DEVIATION REQUEST (Attach diagrams, figures, and other documentation to clarify request)

A deviation from the standards of or in Section **2.2.4.B.5 for Roadway Cross Sections** of the Engineering Criteria Manual (ECM) is requested.

SOLACE APARTMENTS

DEVIATION EXHIBIT
SOLACE APARTMENTS
JOB NO. 25174.00
1/22/20
SHEET 1 OF 1

PROPOSED
PAONIA STREET
TYPICAL SECTION
N.T.S.

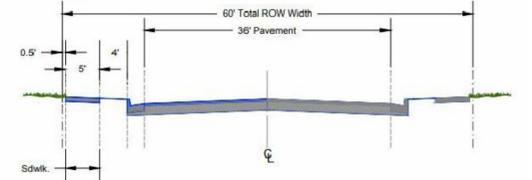
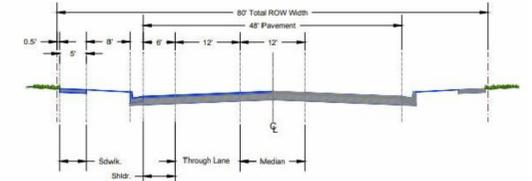
Revise sidewalk location to be 0.5 ft. from the ROW as shown on both collector road sections below.
